<b>Docket Number:</b>	16-SPPE-01
<b>Project Title:</b>	AltaGas Pomona Energy
<b>TN #:</b>	211988
<b>Document Title:</b>	Data Responses Set 1B
<b>Description:</b>	Responses to Data Requests: 5-7, 29, 38-43, 45 and informal Data Requests AQ1 to 2 and TSE1 to 5
<b>Filer:</b>	John Carrier
<b>Organization:</b>	CH2M HILL
<b>Submitter Role:</b>	Applicant Consultant
<b>Submission Date:</b>	6/27/2016 2:04:37 PM
<b>Docketed Date:</b>	6/27/2016

Subject: Data Response, Set 1B  
Pomona Repower Project (16-SPPE-01)

# Pomona Repower Project

## Data Responses, Set 1B

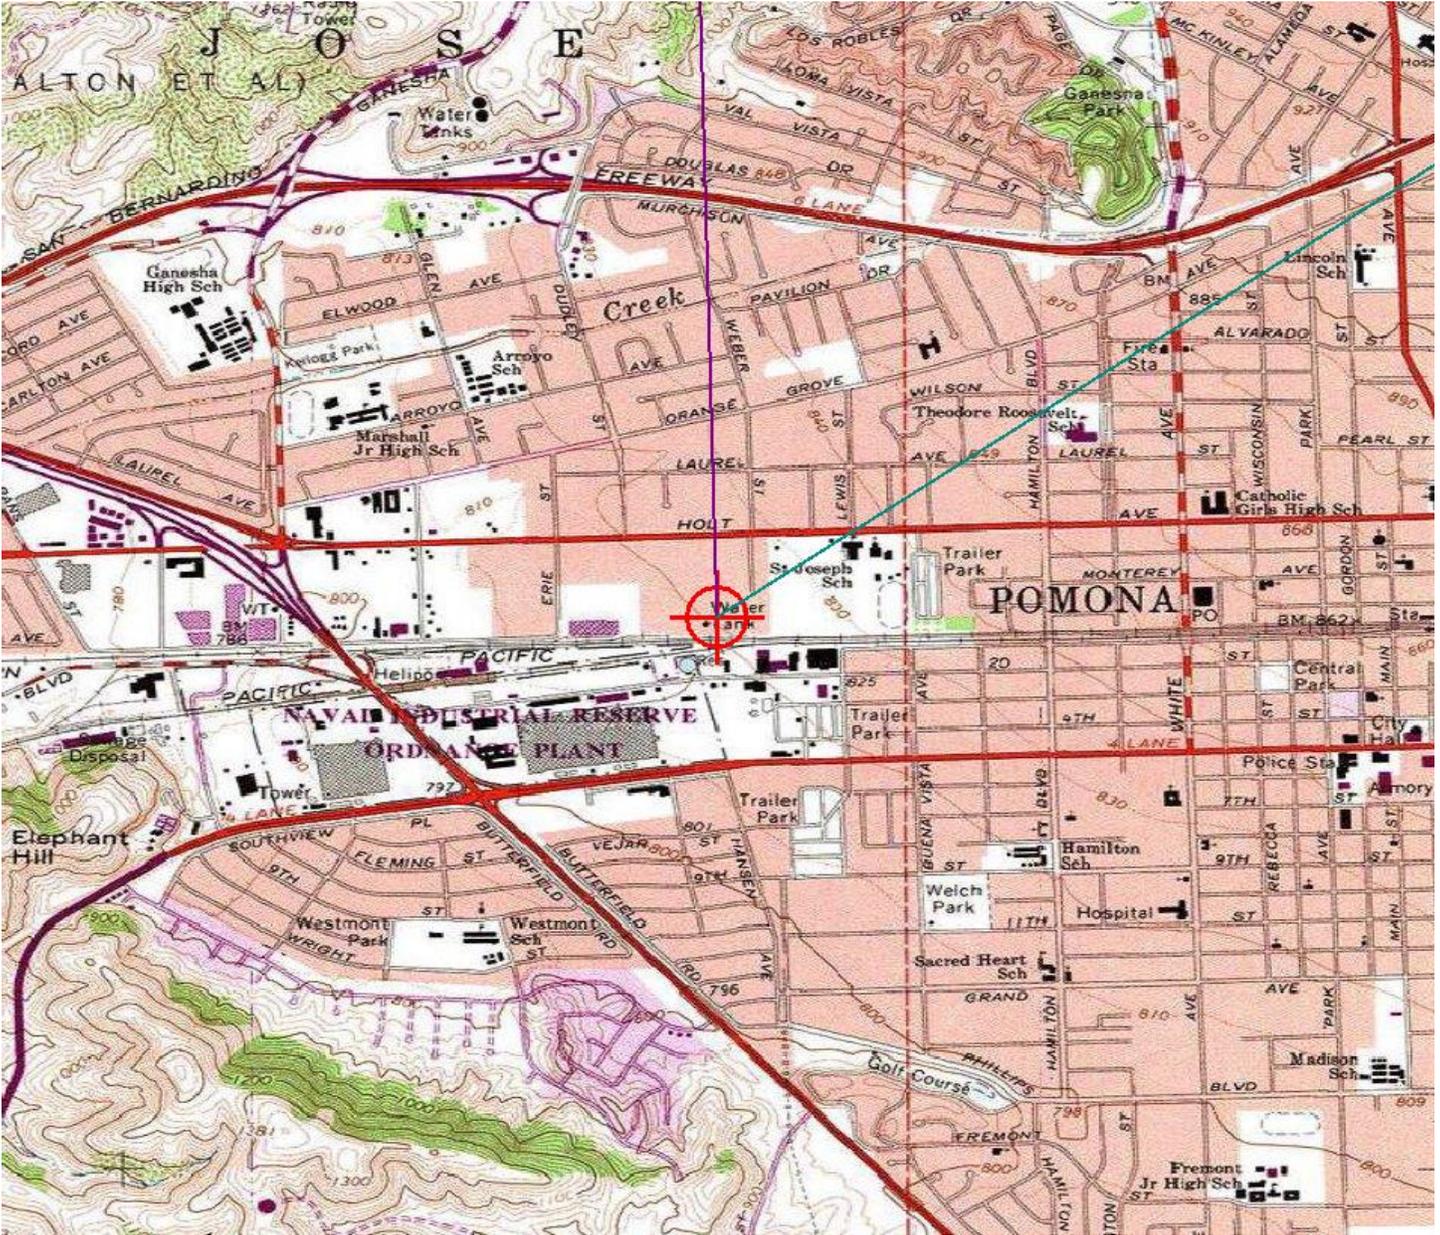
29. If the construction crane(s) would be higher than 90 feet AGL, please provide a copy of the 7460-1 form(s) submitted to the FAA and a copy of FAA's Hazard Determination(s).

**Response:** A copy of FAA's Determination of No Hazard to Air Navigation for Temporary Structure, dated May 31, 2016, is provided as Attachment 29-2.
